Commission of Architectural Review Submission Application

HISTORIC PRESERVATION CERTIFICATION APPLICATION PART 2 – DESCRIPTION OF REHABILITATION

Part 2 Response DHR # 2008-040

CONDITIONS SHEET - Conditions Apply to Part 2 and Subsequent Amendment

D2 PHASE 2 Historic Rehab Tax Credit

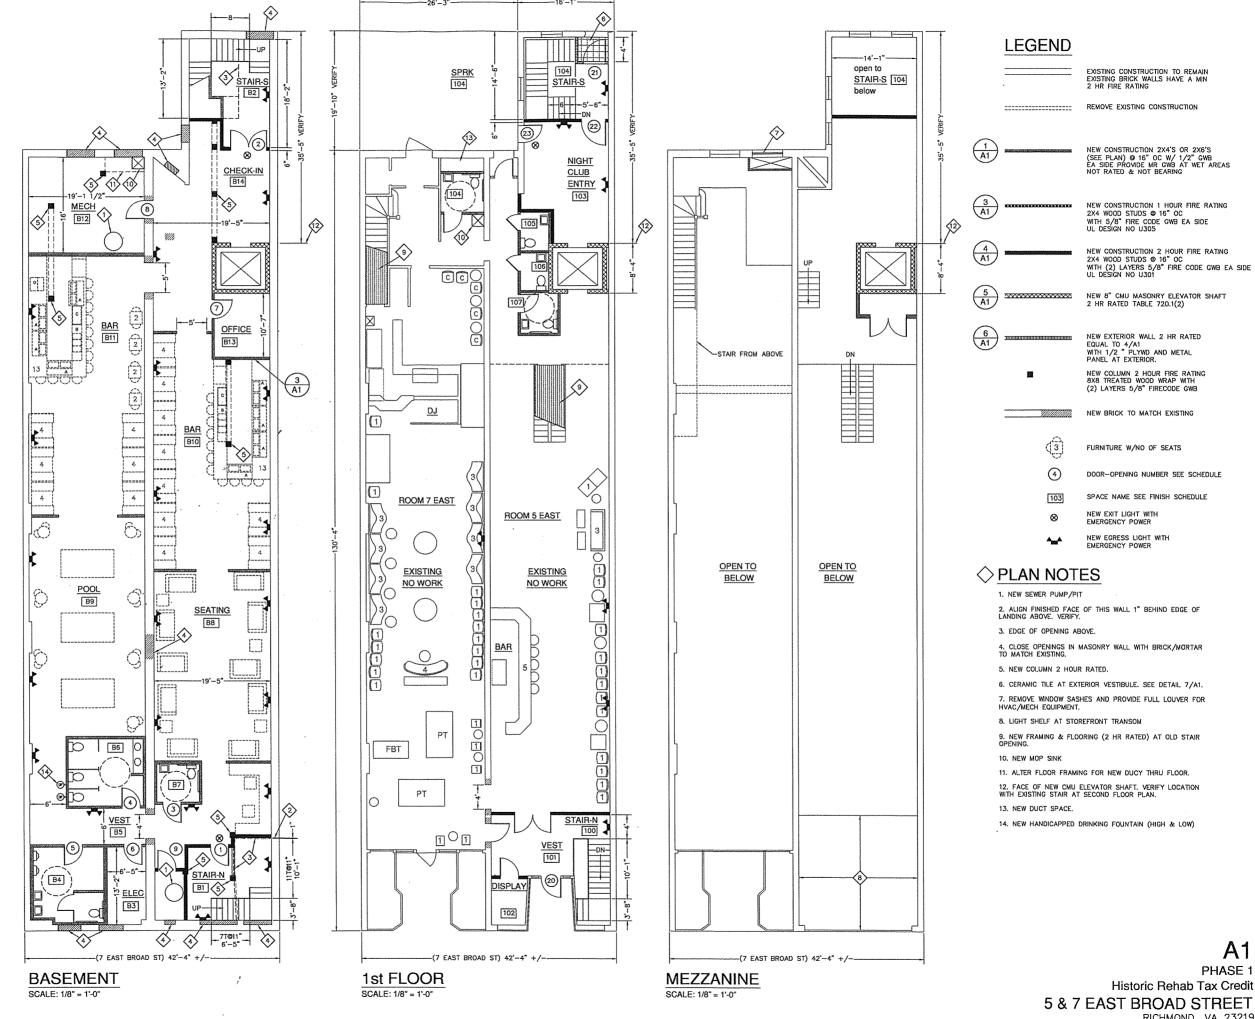
The drawings indicate that Phase 2 work will include enclosing the historic rear stair at 7 East Broad Street with a rated wall. This stair should not only remain intact but also visible; its enclosure would conflict with Standard 2:

Standard 2 ~ The historic character of a property shall be retained and preserved. The removal of historic materials or alterations of features and spaces that characterize a property shall be avoided.

BROAD STREET NORTH ELEVATION

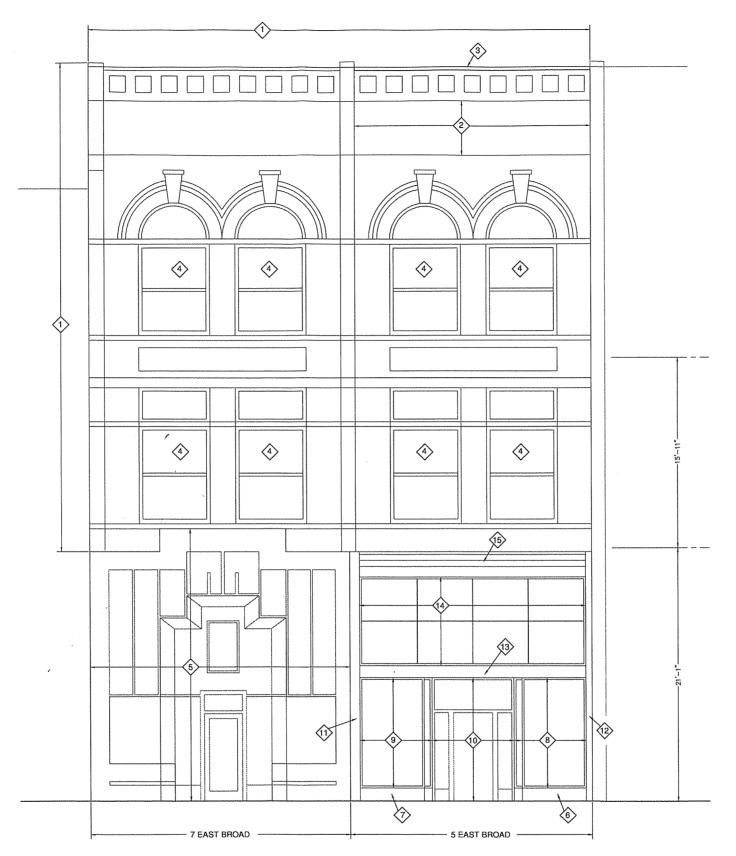
Historic Photo ~_please submit a copy of the historic photo referenced on the drawings. We cannot review the proposed work to the storefronts or the construction of the interior vestibule or stair until we have reviewed this image.

As noted above, we cannot review or comment on the work proposed to both of the storefronts or the addition of an interior stair and vestibule at 5 East Broad Street until we have received and reviewed the historic photo. Work should not begin at any of these areas until DHR has received the photo and commented on the proposed rehabilitation.

A5

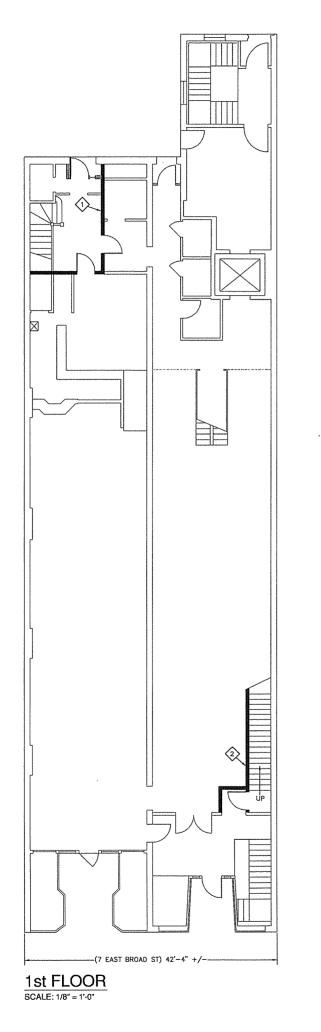
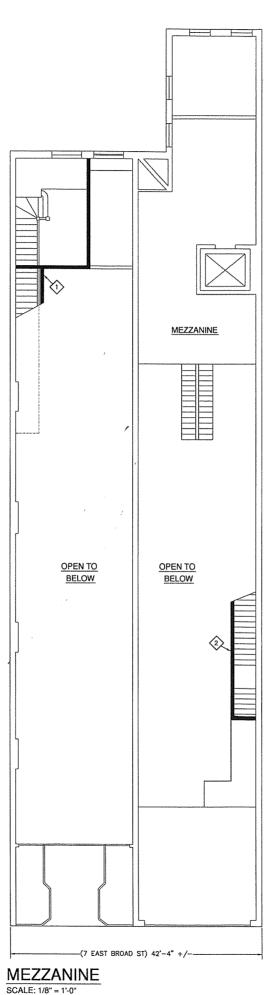
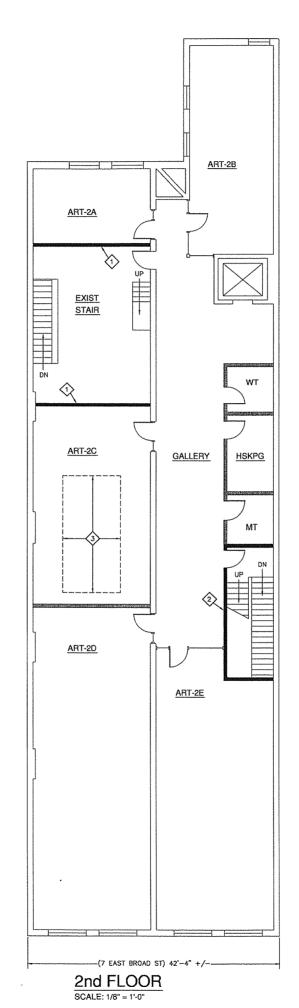
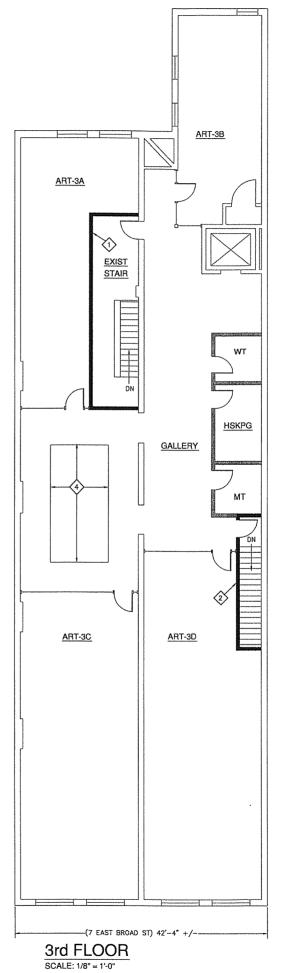
Approval does not extend to the following items: The enclosure of the historic stair
